Hillingdon

Outline Fire Strategy – Rev E

OF-OFS-3671-01-E

Appendix A – Drawing Comments

3 Building 10 - Sixth Floor Plan
1 : 200

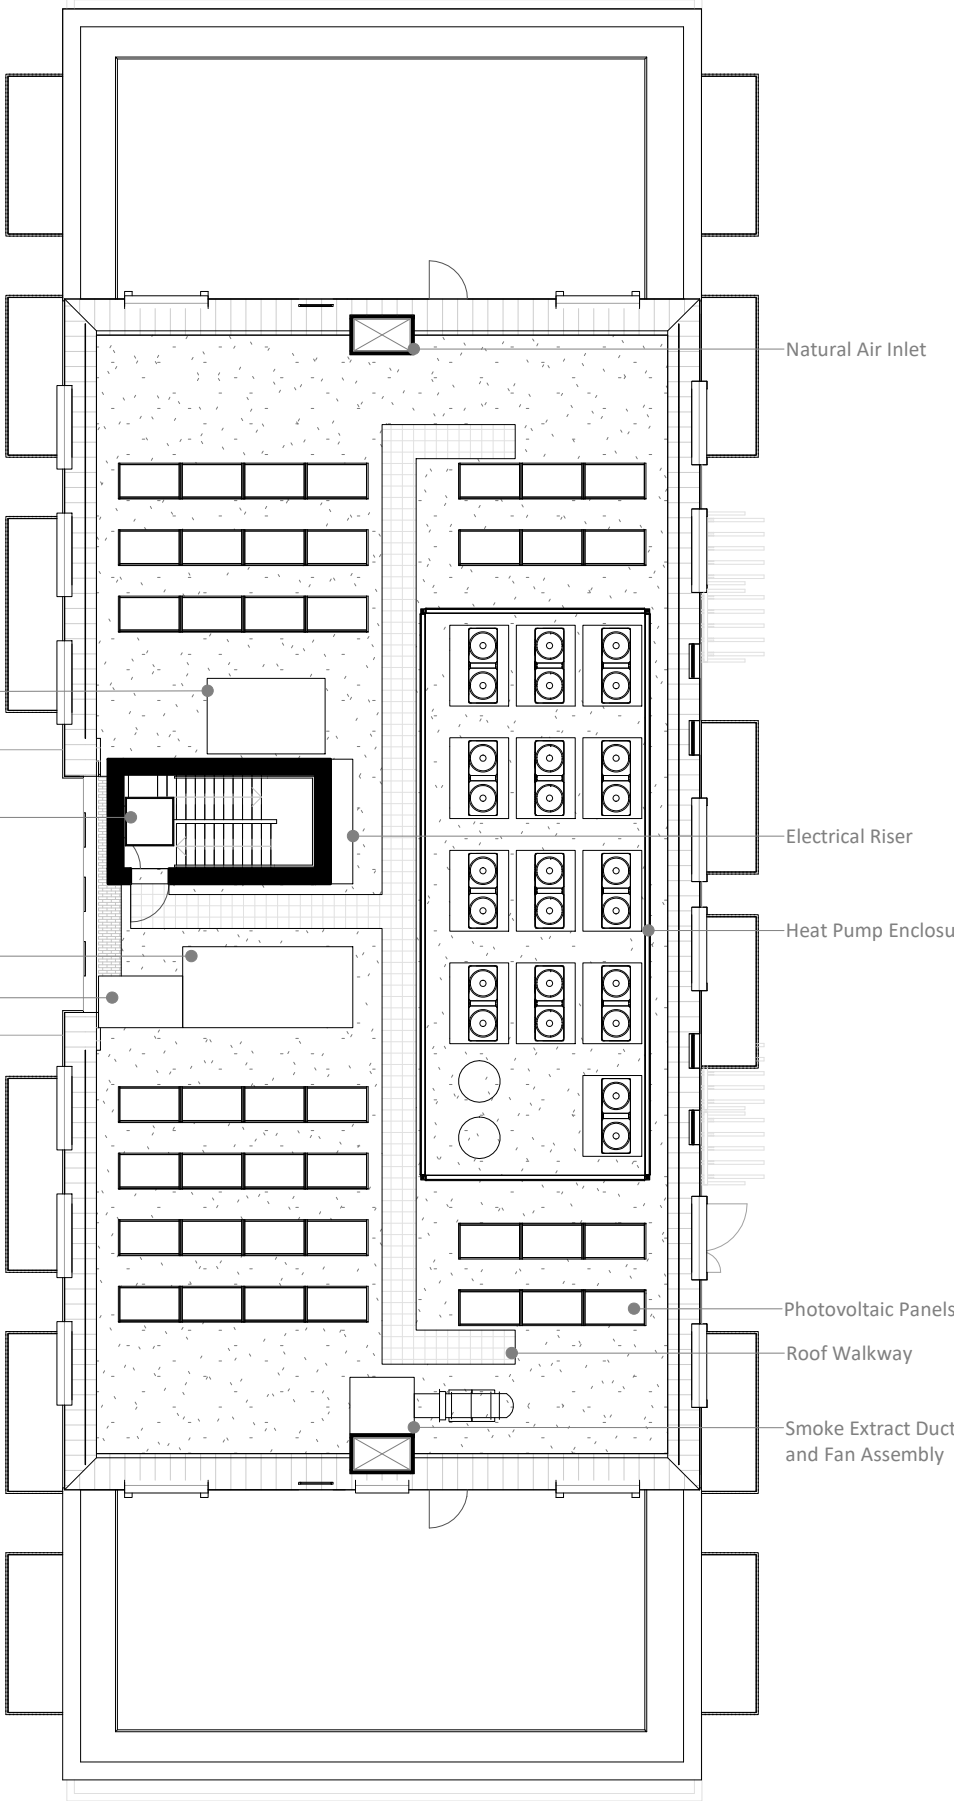
To be noted, if the service riser is to only contain water services or metal ventilation ductwork from the ground floor, it is considered a limited fire hazard. As such, this riser shaft may be located in the staircase lobby.

The cross-corridor doors and the lobby AOV's direct to the external are to be omitted, allowing for 2x 0.8m² mechanical smoke shafts are to be provided at the remote ends of the corridors (one at each end). CFD modelling would be required to justify this deviation. However, considering that the travel distance isn't excessive and that the apartments are not impeding the vertical escape route, it is considered that this proposed solution has limited design risk.

1 Building 11 - Ground Floor Plan
1 : 200

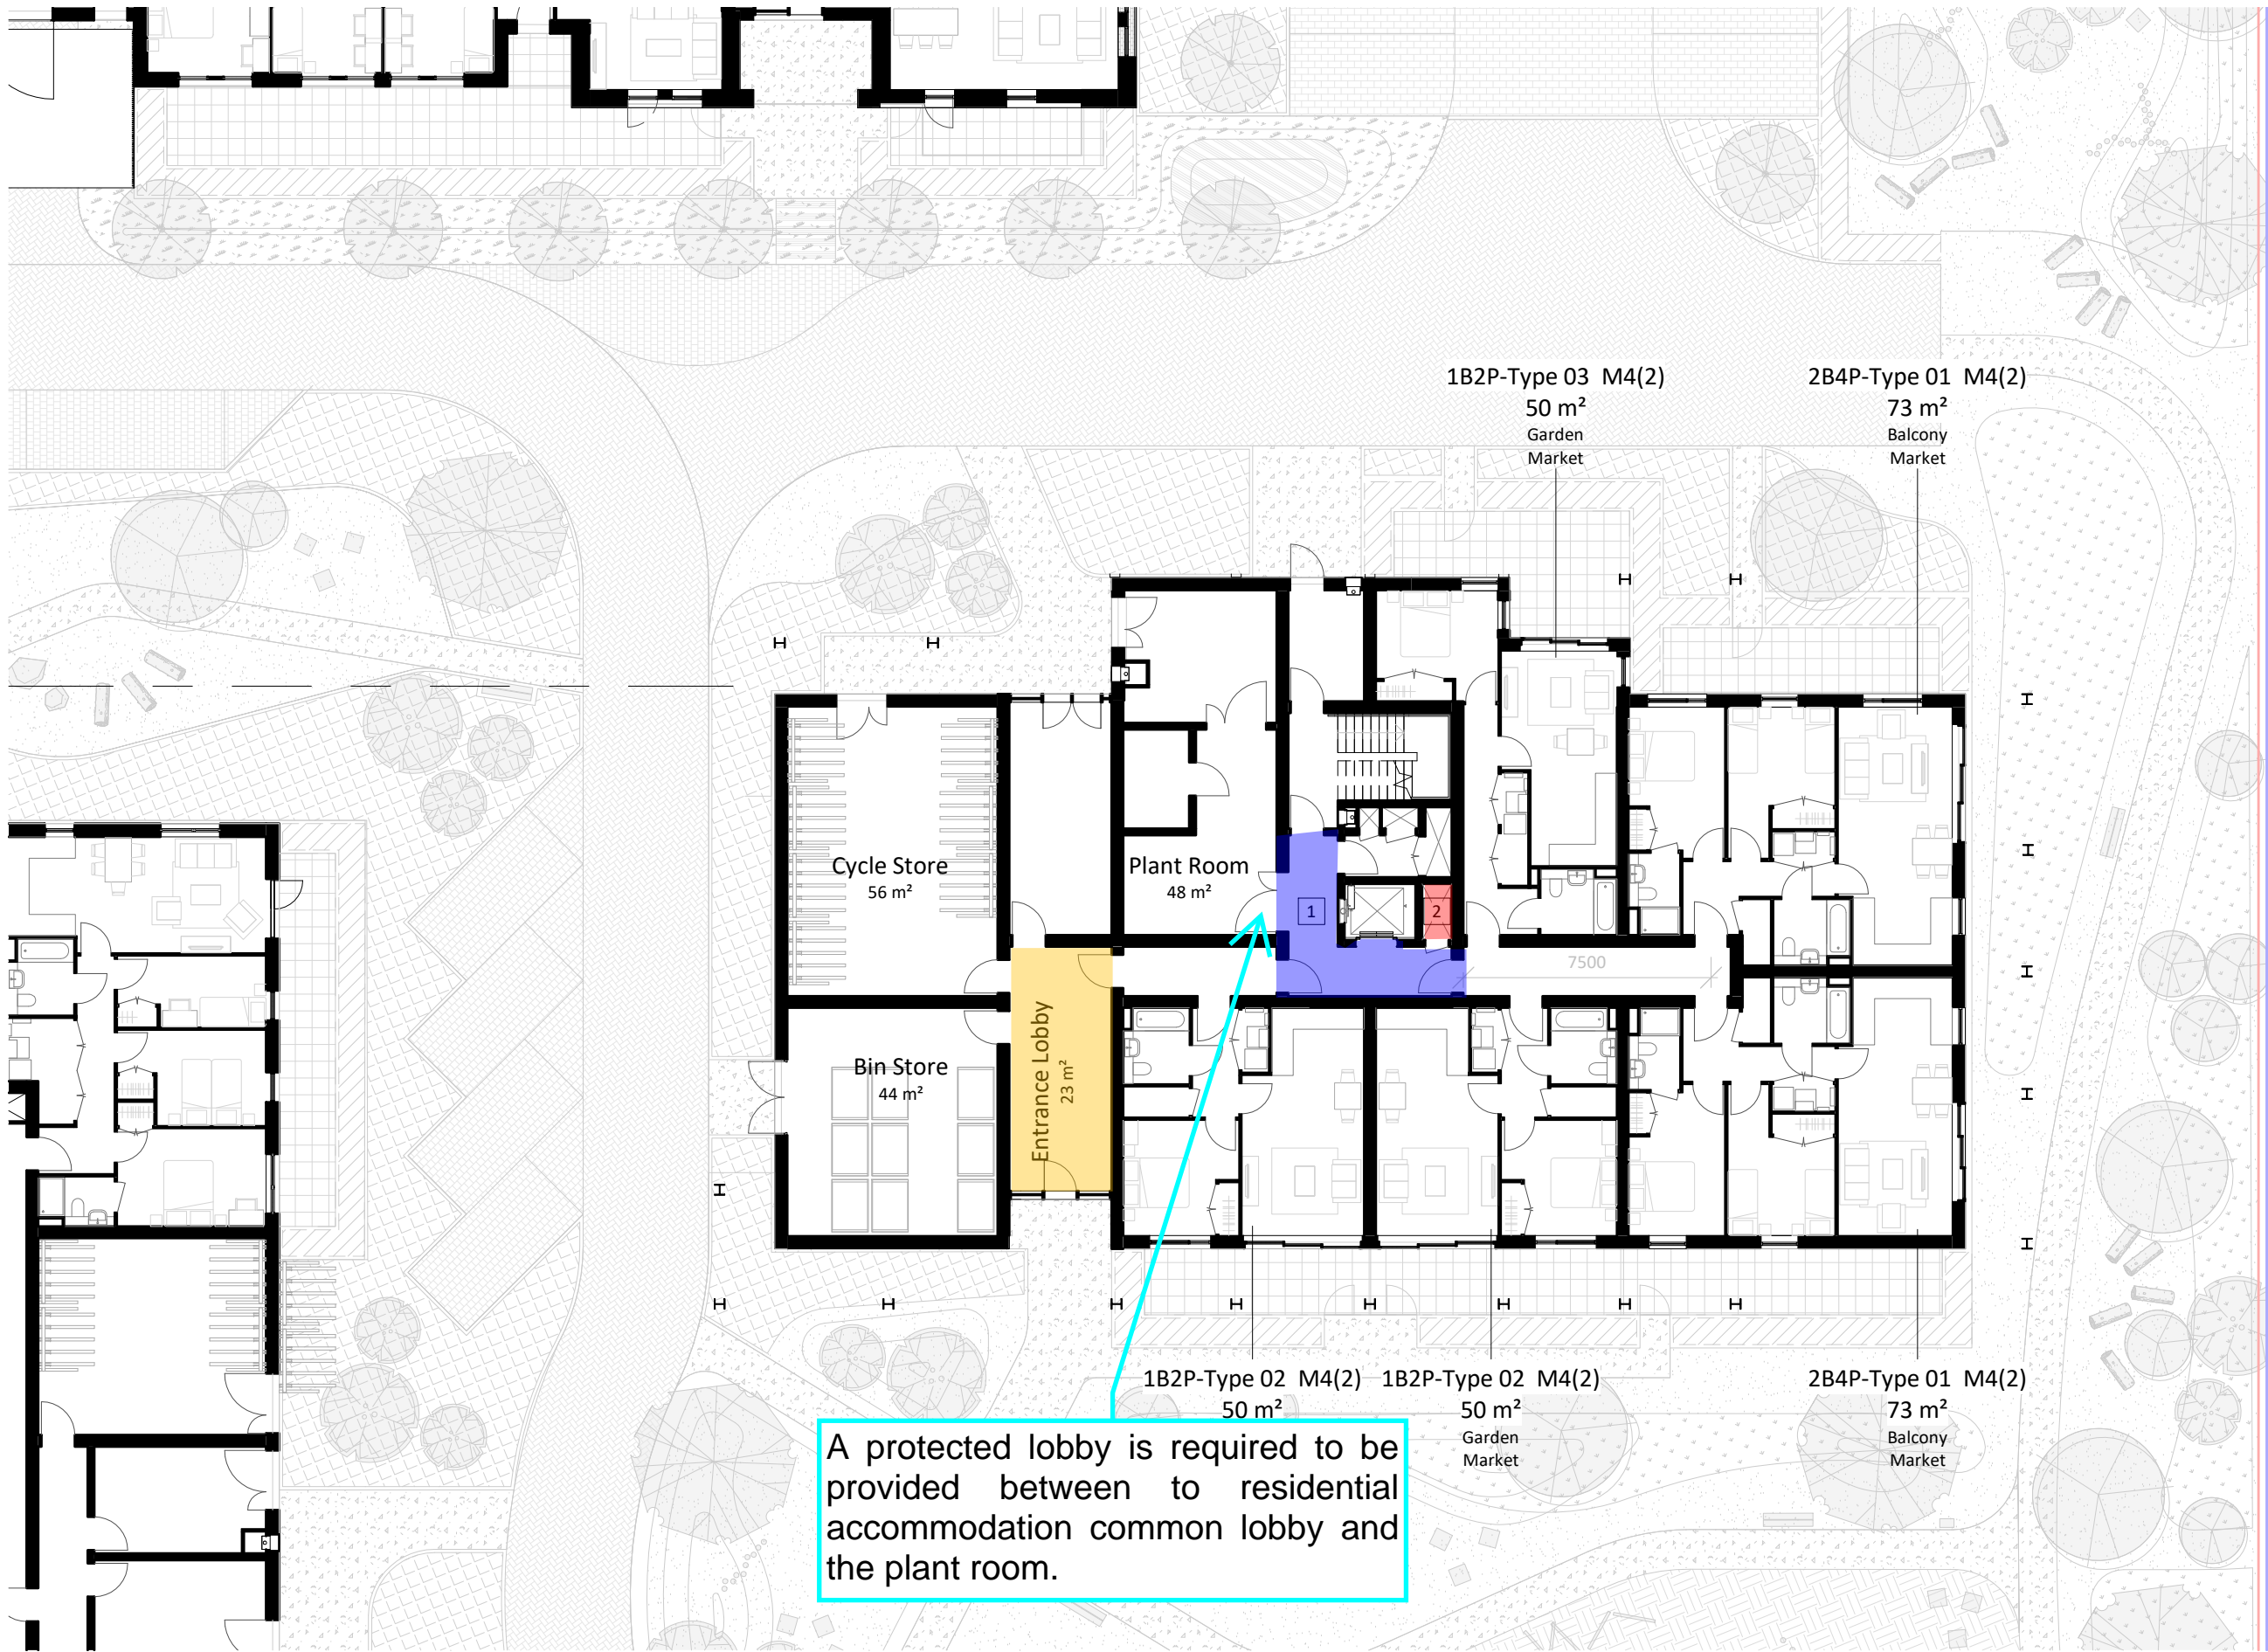
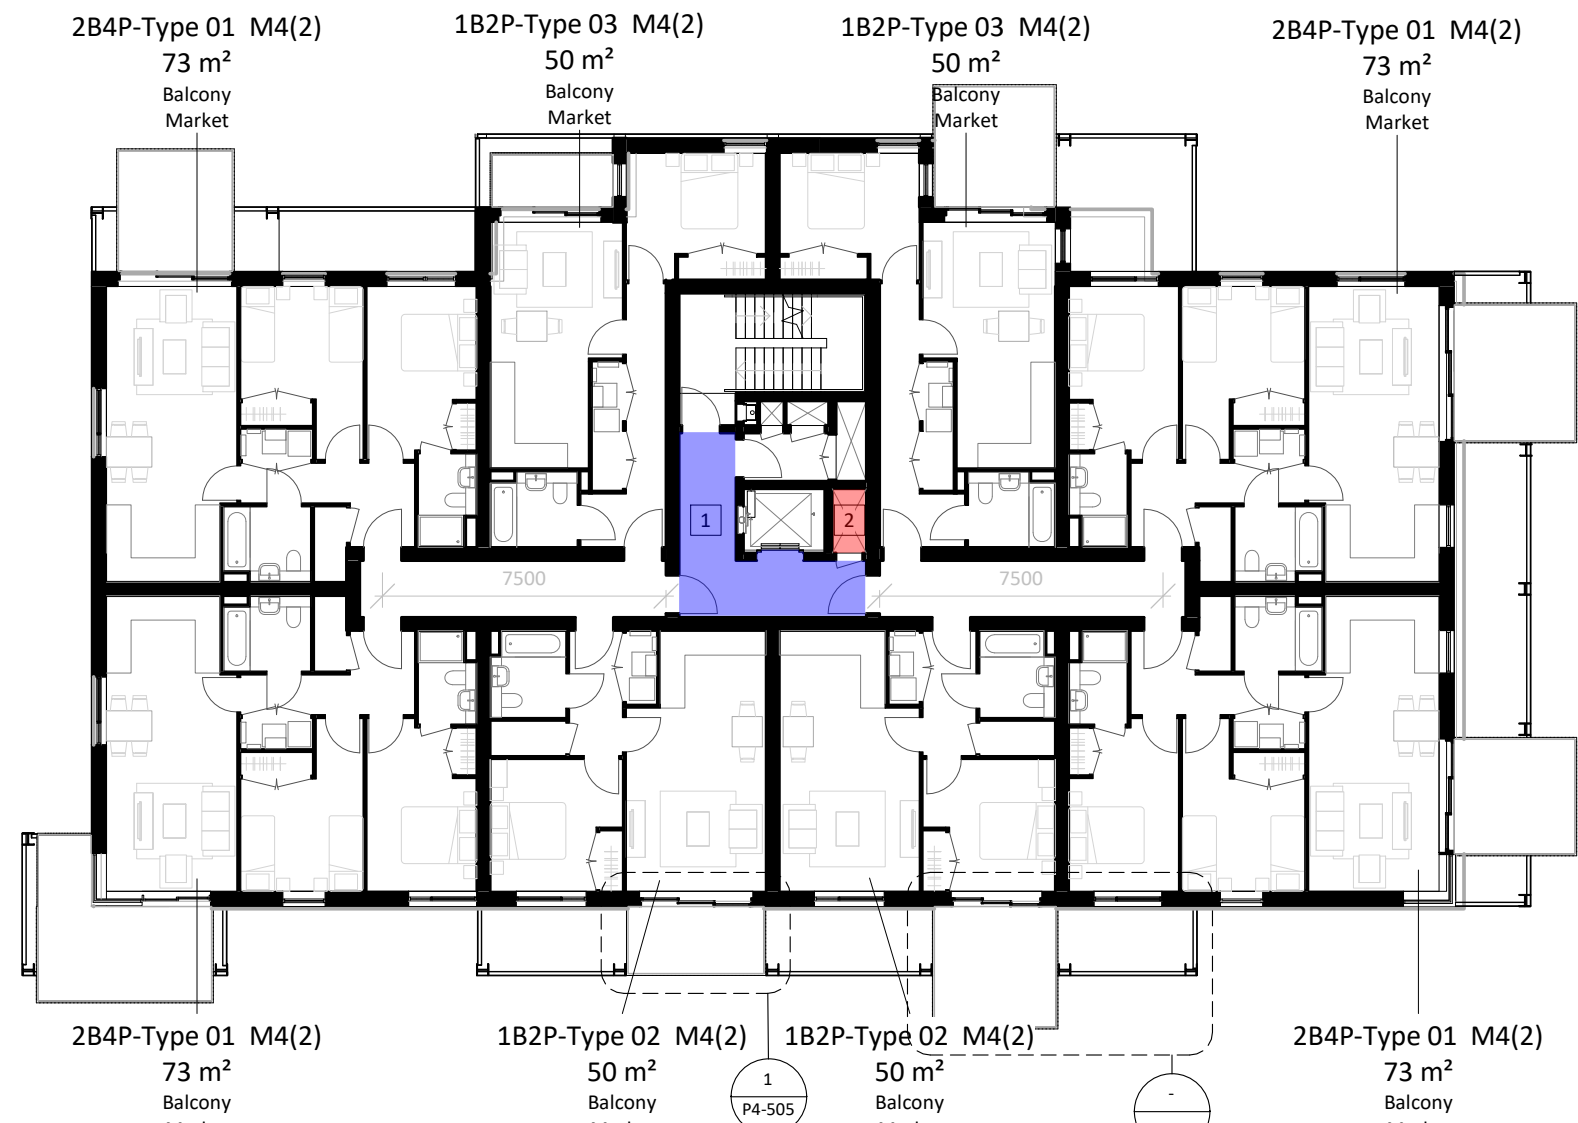
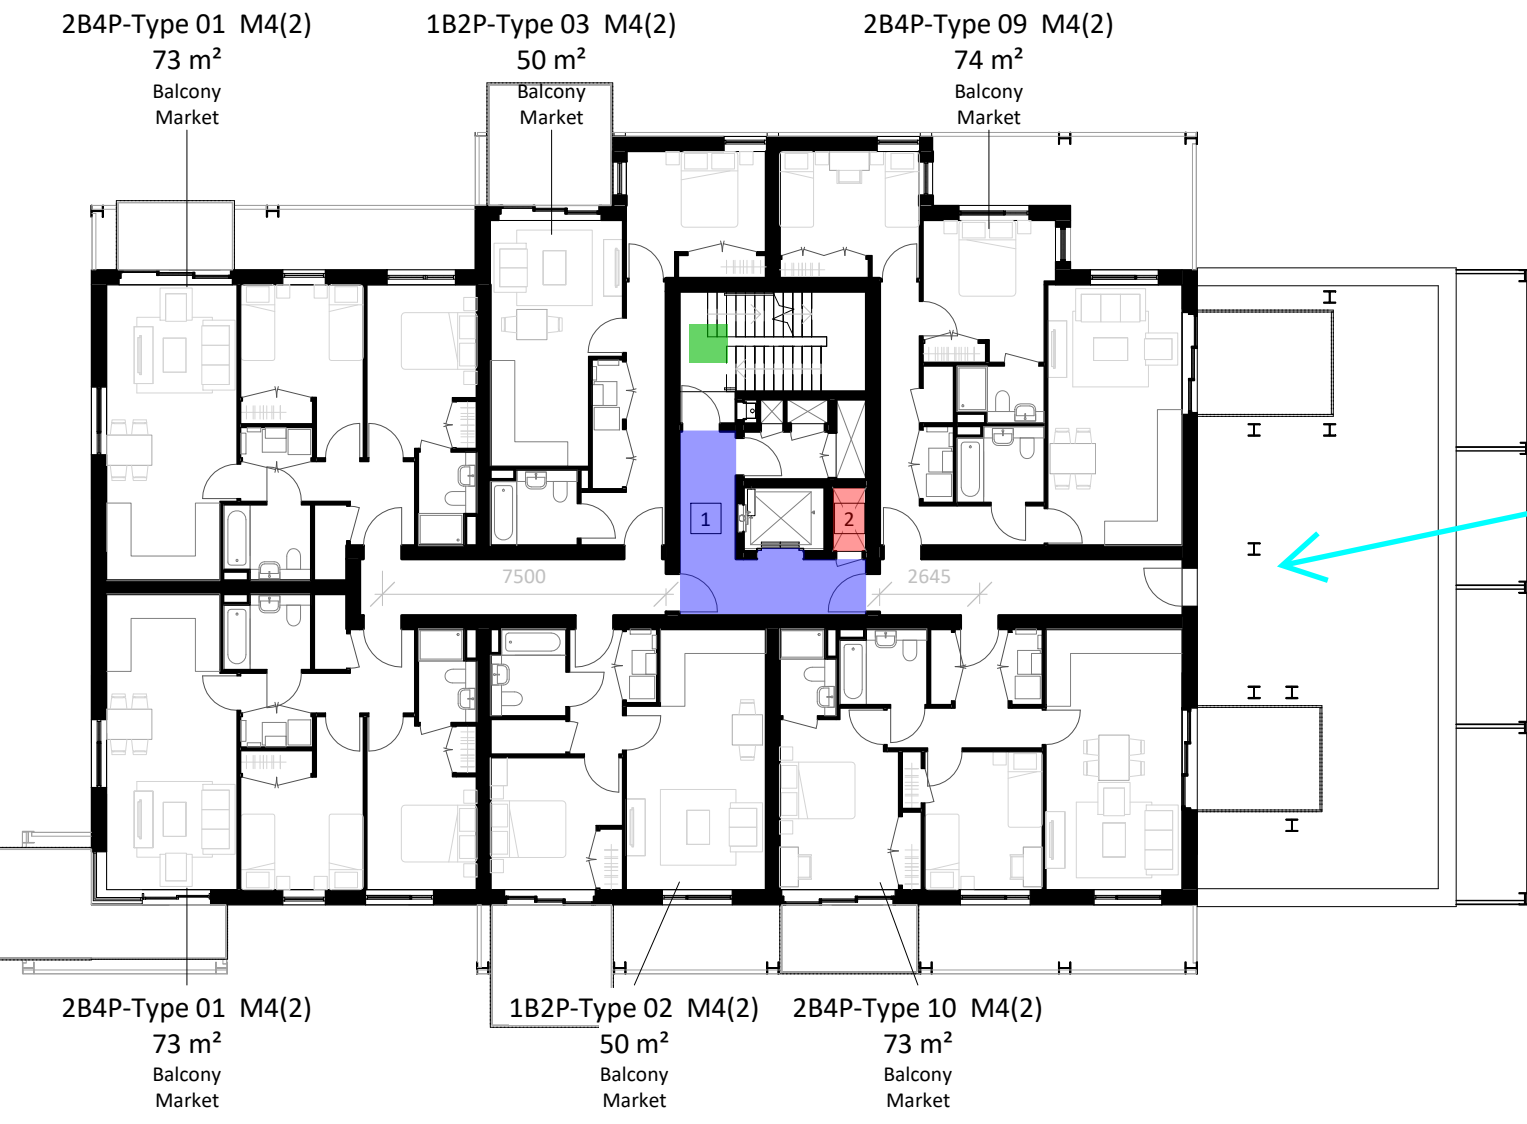
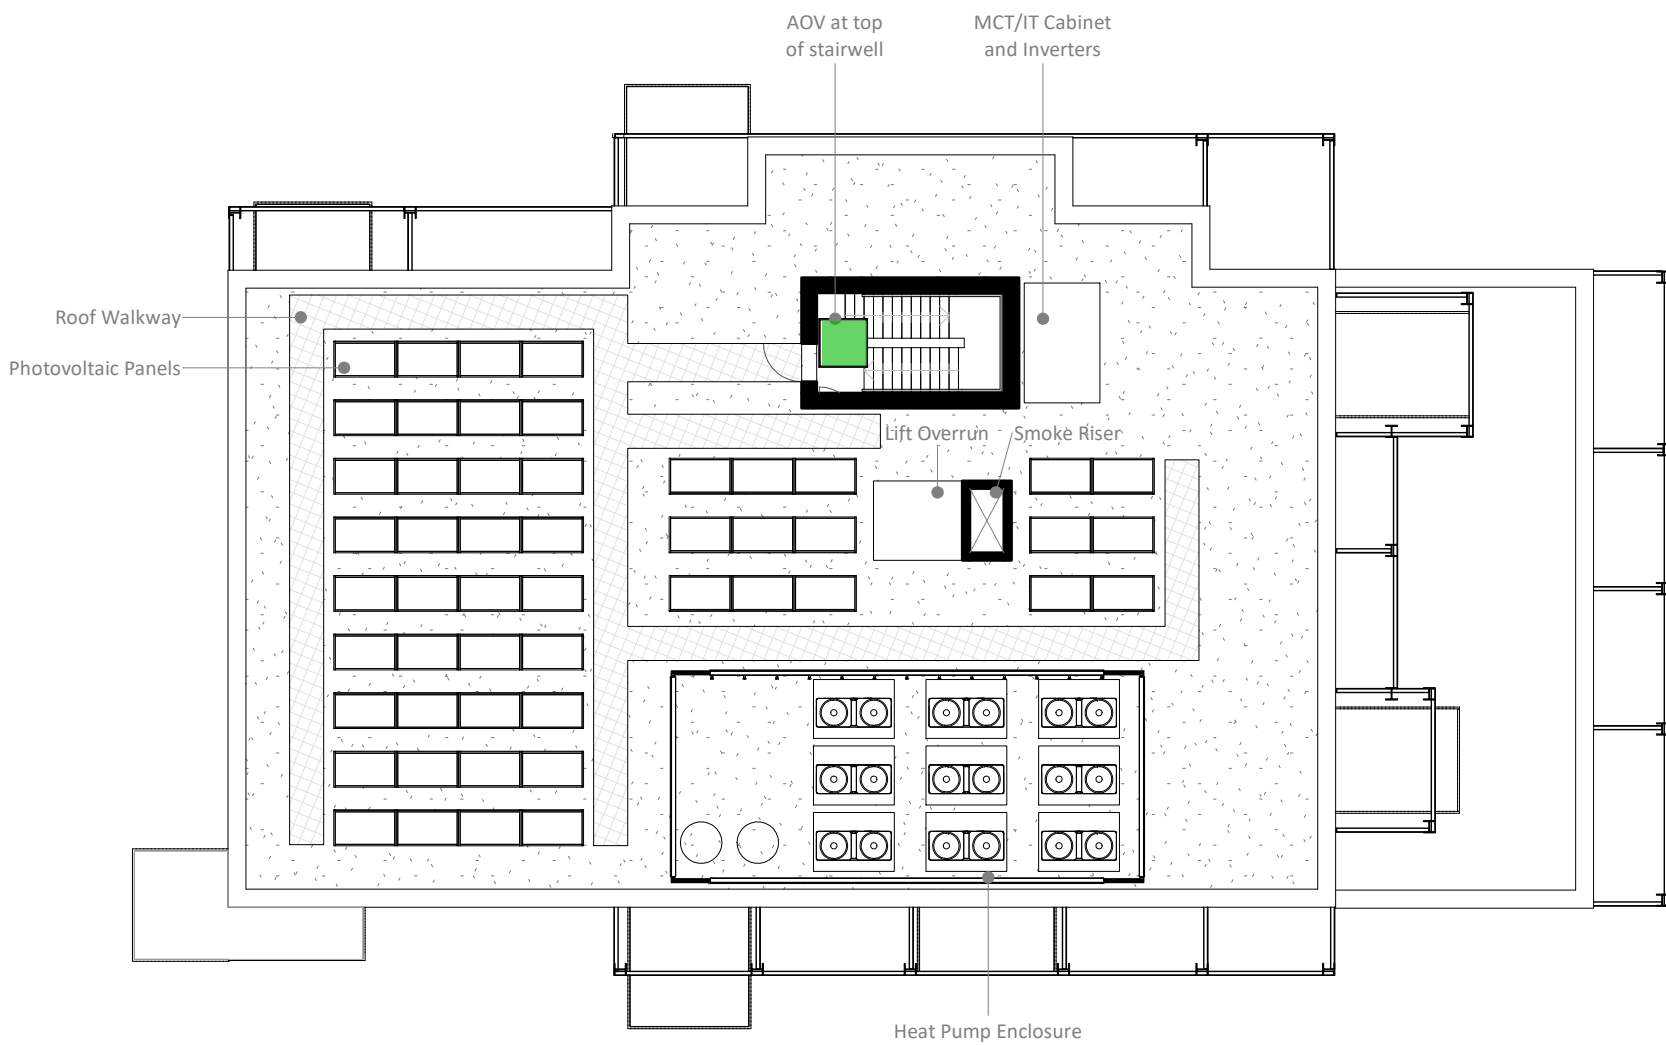
The maximum travel distance from the furthest point to protected firefighting staircase is to be within 18m. This is currently not achieved, as such the common corridor is required to be provided with enhanced detection and smoke ventilation. This is to agreed with Building Control and the Fire Service at the detailed design stage.

To be noted, if the service riser is to only contain water services or metal ventilation ductwork from the ground floor, it is considered a limited fire hazard. As such, this riser shaft may be located in the staircase lobby.

To be noted, the government have stated from May 2020, all new building's over 11m in height are required to be provided with sprinklers, see Section 9.
